**49 CFR Part 572**

**Anthropomorphic Test Devices; Hybrid III 6-Year-Old Child Test Dummy, Hybrid III 6-Year-Old Weighted Child Test Dummy**

**ACTION:** Final rule.

Figure 1: Illustration of femur assembly

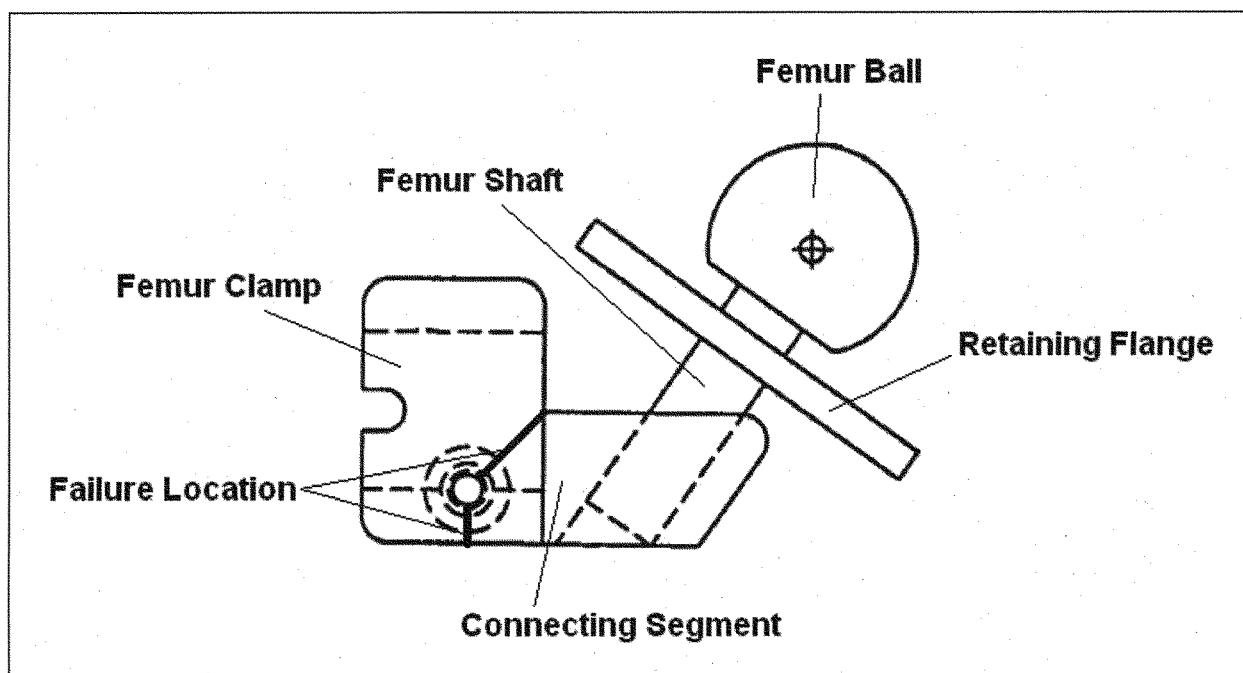
Failures of the HIII-6C femur appear to have initiated at a sharp corner between the femur clamp and connecting segment sections of the machined femur. The approximate location of the femur failure is depicted in Figure 1. The fracture was observed from this corner to the bolt hole within the femur clamp, at an angle of approximately 45°. The failure continued through the thin section of material directly beneath the bolt hole,

The modification made today to improve the femur’s durability increases the strength and durability of the femur assembly by fabricating the machined femur and shaft from 4340 steel, which has a higher yield strength than the original material, Aluminum Bronze C-624 AMC0-18, while keeping the ball and retaining flange as the original aluminum bronze material. A ¼-inch (6.35 mm) fillet is added between the

femur clamp and the connecting segment to eliminate stress risers that were present on the original femur, and a portion of the connecting segment

To implement this change in femur design and material, the following changes are made to the materials describing the HIII-6C in 49 CFR part 572. Drawings 127-3017-1&-2, “6 YR H3-FEMUR MACHINED” is replaced with drawings 127-3017-1S&-2S, which show the new machined femur.<sup>3</sup> The femur assembly drawings (127-3016-1&-2) are also replaced due to the new femur design, with new part numbers 127-3016-1S&-2S. Higher assembly drawings including 127-3000, “LOWER TORSO ASSEMBLY” and the complete assembly drawings (127-0000) are amended to show the modified part. These revisions are noted on drawing SA572-127DRL-2. The PADI is also updated so that it shows the new machined femur in figures, and reports the proper lower torso assembly and total weight for the dummy. Finally, the part numbers for the machined femur and the femur assembly are changed in the Parts/Drawings list, along with the revision letters for higher assembly drawings, as appropriate.

Figure 7: Portions of the HIII-6C abdomen insert drawing

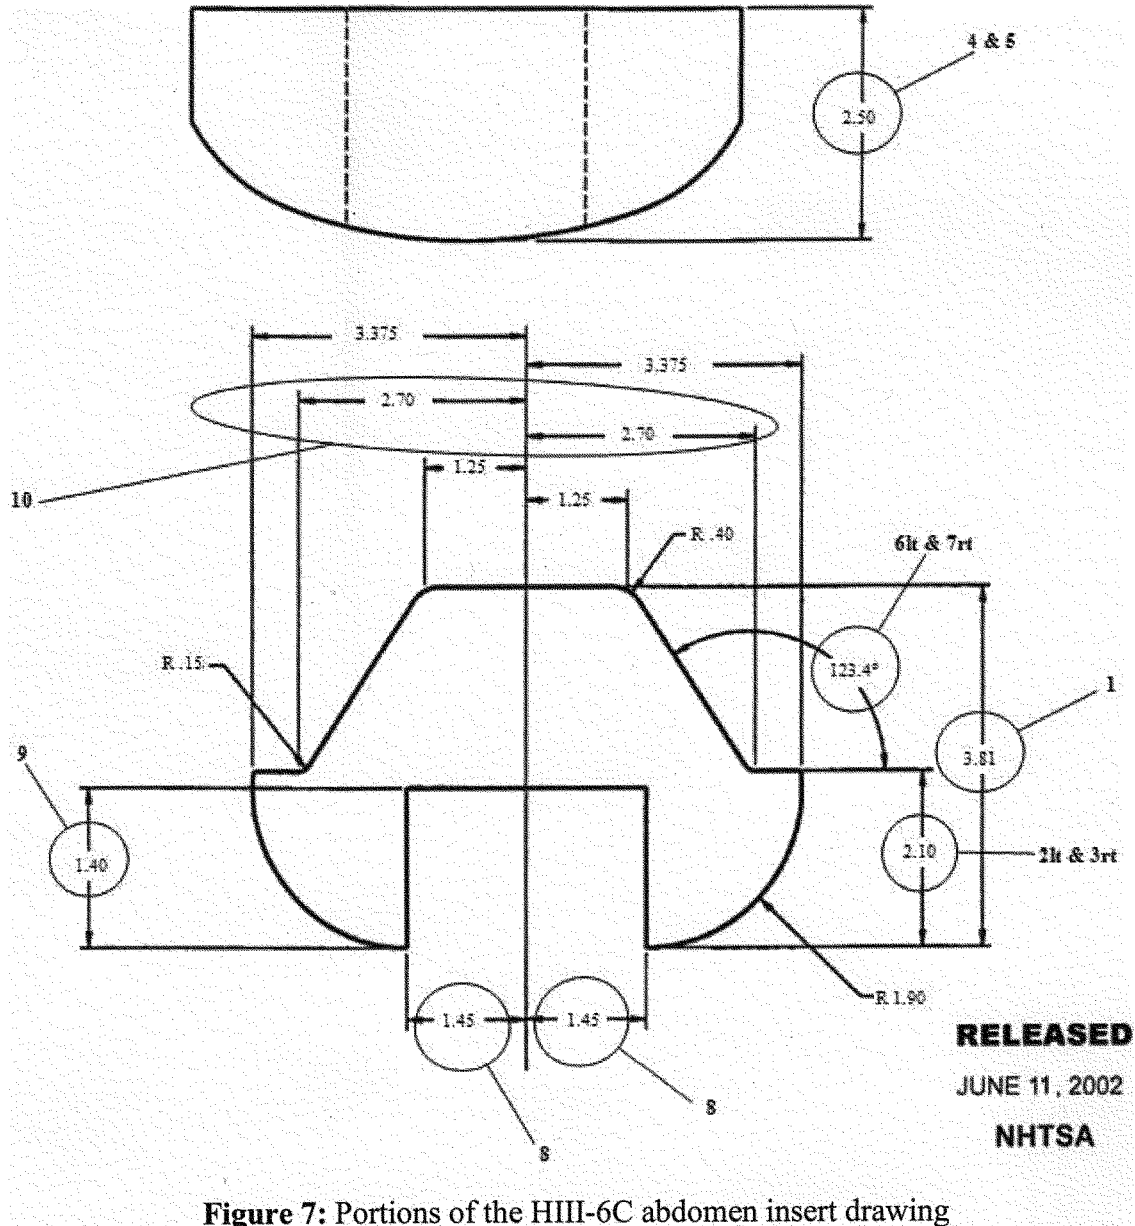
This final rule changes Drawing No. 127–8210 of the HIII–6C drawing package, which depicts the abdominal insert for the dummy. It makes a similar change to the HIII–6CW drawing package.<sup>8</sup> This change responds to a petition from FTSS and Denton. Both manufacturers sought to revise the abdomen insert drawing to match the part mold dimensions.

Table 4 shows the changes this final rule makes to key abdomen dimensions. “Fig. Ref” numbers in the table refer to Figure 7, which shows the original dimensions.

Description	Fig. ref.	Adopted spec.
Overall height (in.) .....	1 .....	3.81 +/- .20
Ledge height (in.) .....	2lt .....	1.53 +/- .20

Description	Fig. ref.	Adopted spec.
Depth excl. plug (in.) .....	3rt .....	1.53 +/- .20
Depth incl. plug (in.) .....	4 .....	2.80 +/- .20
Taper angle of cone (degrees) .....	5 .....	2.80 +/- .20
	6lt .....	121/129
	7rt .....	121/129
Notch Half Width (in.) .....	8 .....	1.50 +/- .20
Notch Depth (in.) .....	9 .....	1.40 +/- .20
Width Bottom of Cone (in.) .....	10 .....	5.40 +/- .40
